# Town of Washington Inland Wetlands Commission

## PERMIT APPLICATION

RE: Review of Engineering Plan for Subsurface Sewage Disposal System located at:  
210 West Shore Road - Washington

SEPTIC SYSTEM REPLACEMENT PLAN		
EXISTING HOUSE 210 WEST SHORE ROAD WASHINGTON, CONNECTICUT		
DATE: 12-1-2020	BRIAN E. NEFF LICENSED ENGINEER 128 BACON ROAD ROXBURY, CT 06783 (860) 334-2246	DRAWN BY: B.E. NEFF DRAWING NUMBER: SHEET 1 OF 1

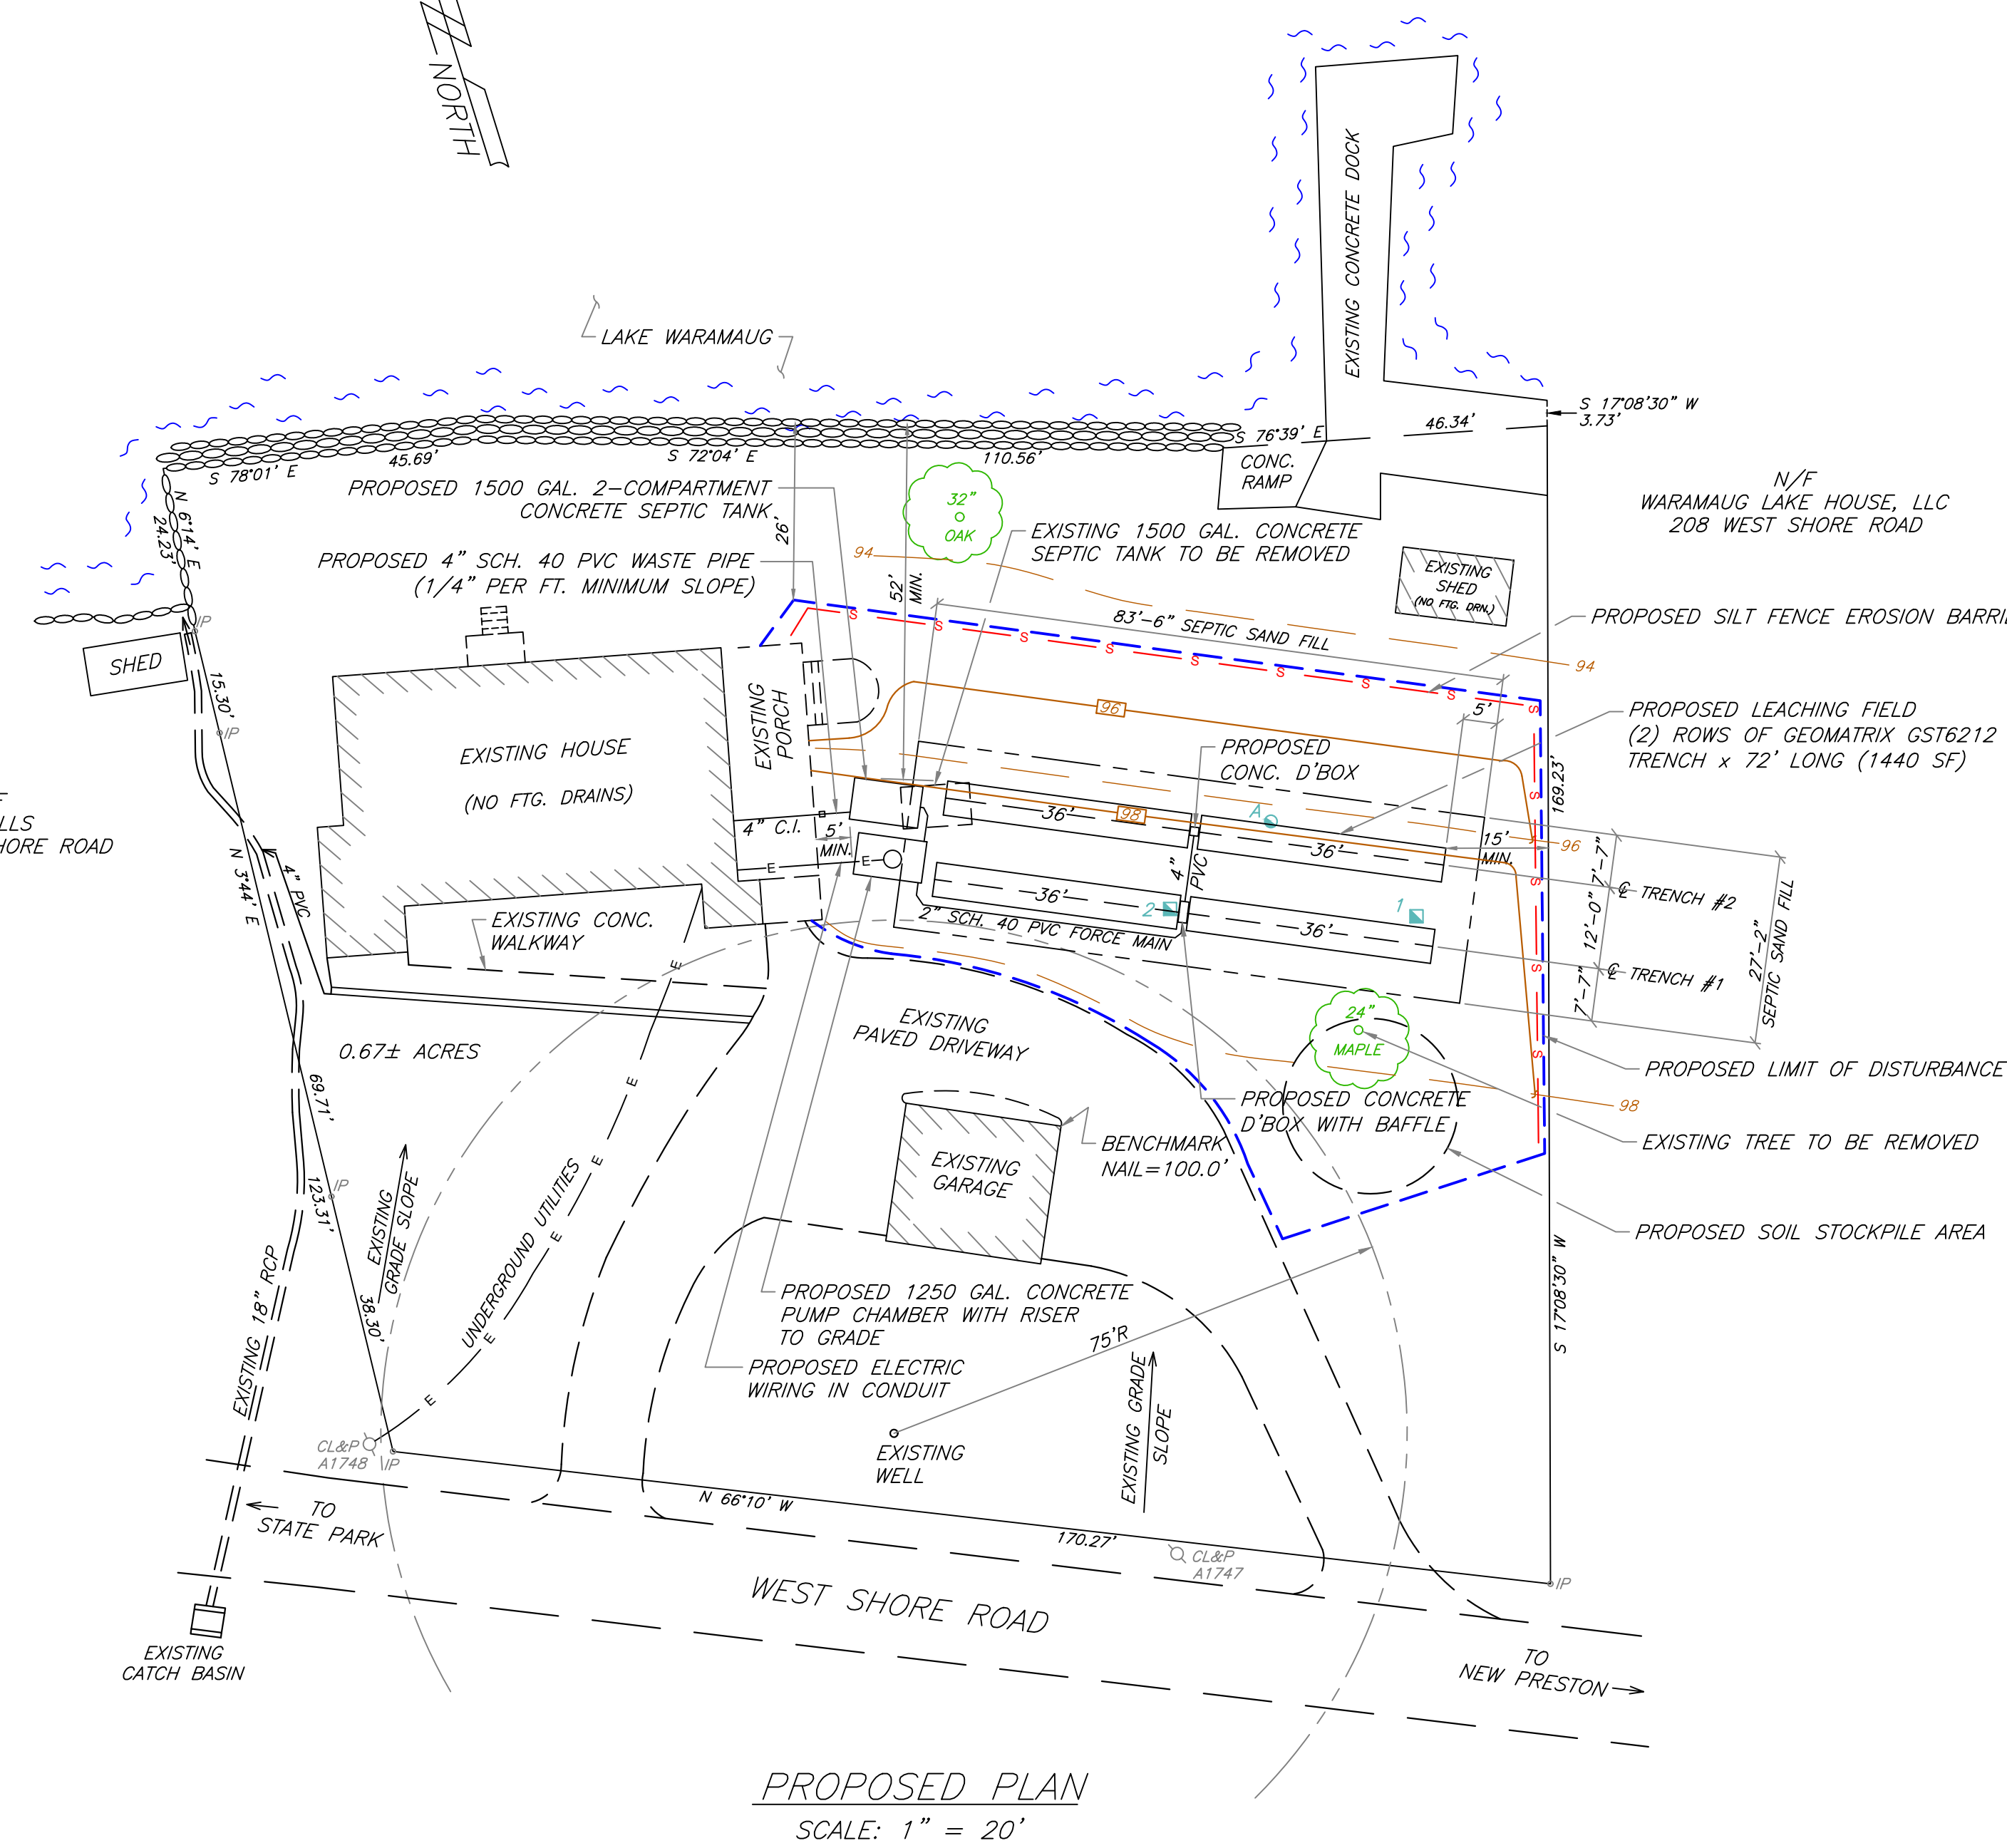
This system does not provide for water softener discharges OR kitchen garbage grinders.  
1. Engineer to stake all components of the septic system prior to construction. 2. Engineer to approve quantity, quality and placement of select fill. 3. a percolation test is required in the fill package along with a submittal of the sieve analysis. 4. Engineer to submit an as-built to the Health Department.
